WATER PERMIT NO. 7862-3

Water Permit Application No. 7862-3
Circle Bar Ranch, Inc.

August 6, 2013

REPORT ON
WATER PERMIT APPLICATION No. 7862-3
Circle Bar Ranch Inc.
c/o William O'Farrell
July 23, 2013

SKETCH PLAN OF DAM AND RESERVOIR AREA

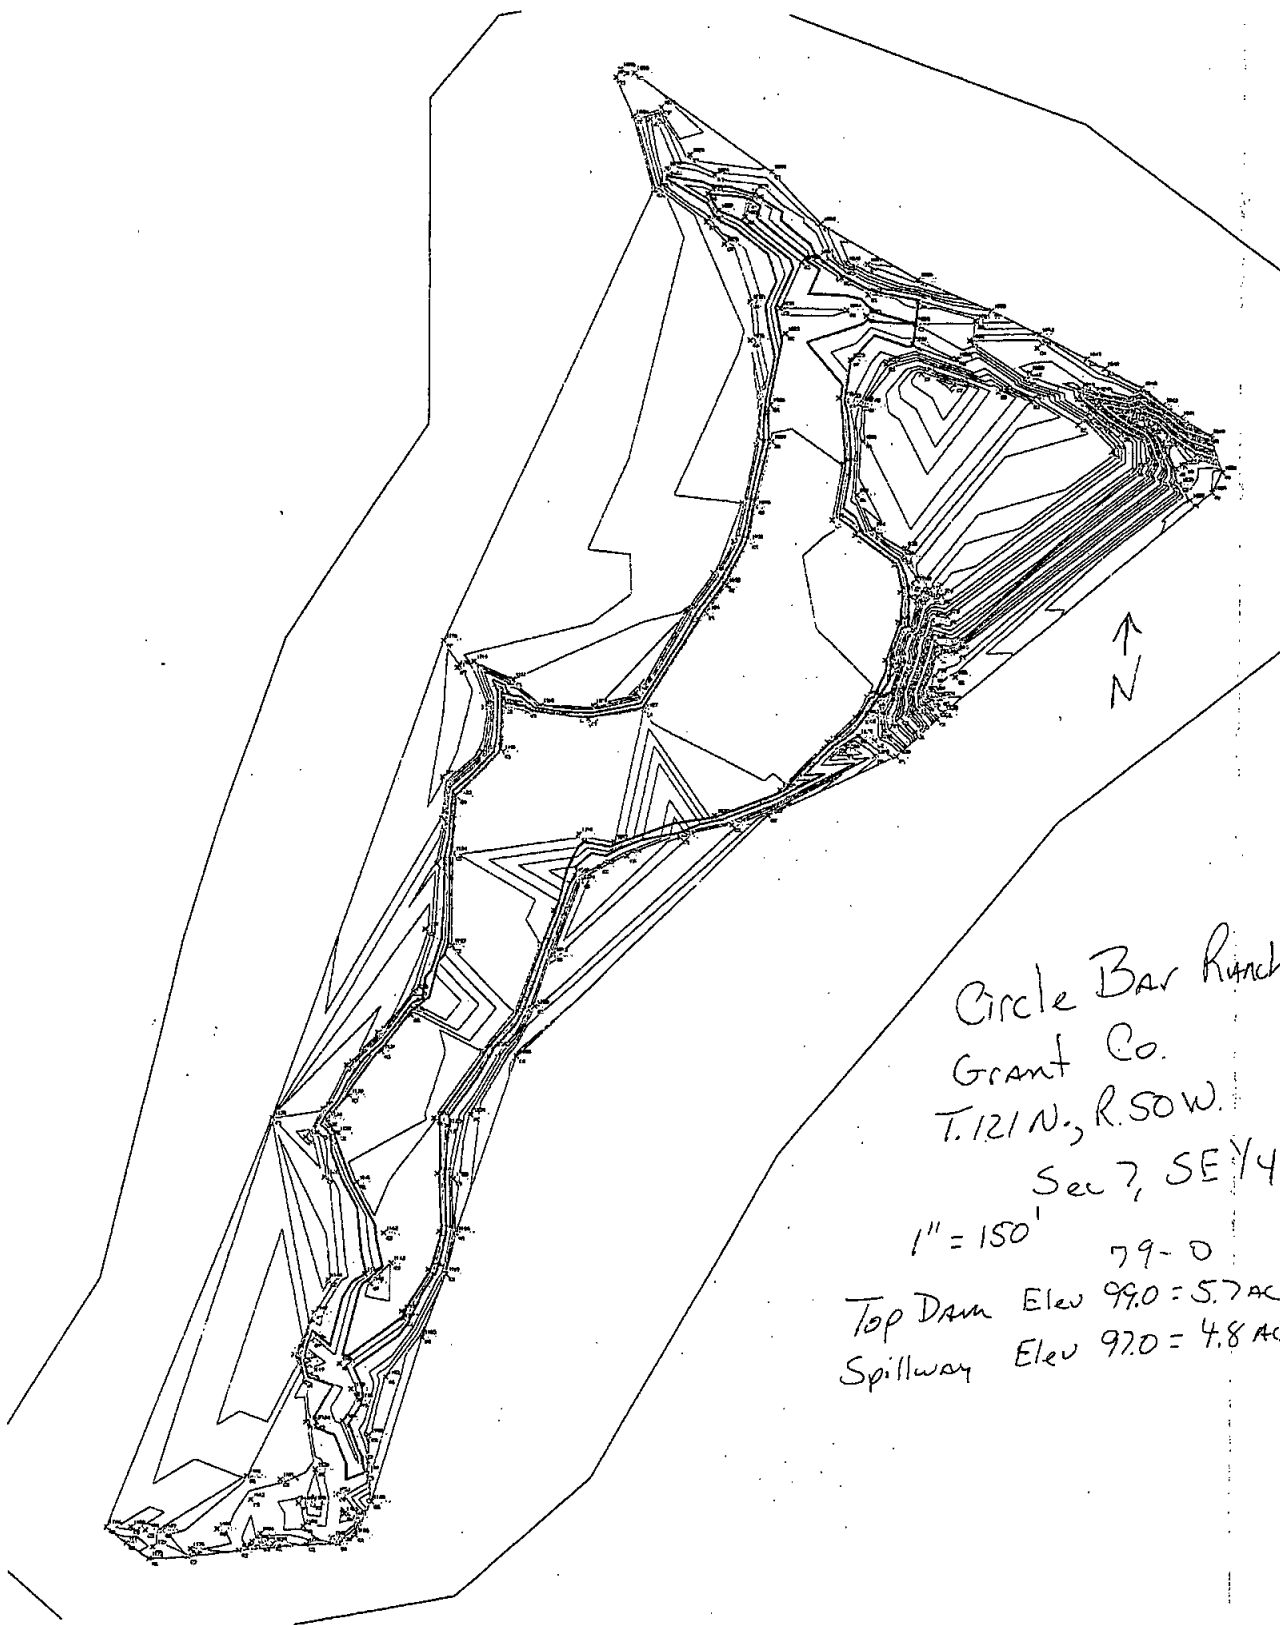
1. Topo Map - OK
2. Dam Axis Profile - OK
3. Dam Max X-Sec. - OK
4. Area Capacity - OK
5. Outlet Details - OK
6. Spillway Routing - OK
7. Spillway Details - OK
8. Specs - Std NRCS - OK
9. EPP - N/A Cat. 3 - OK
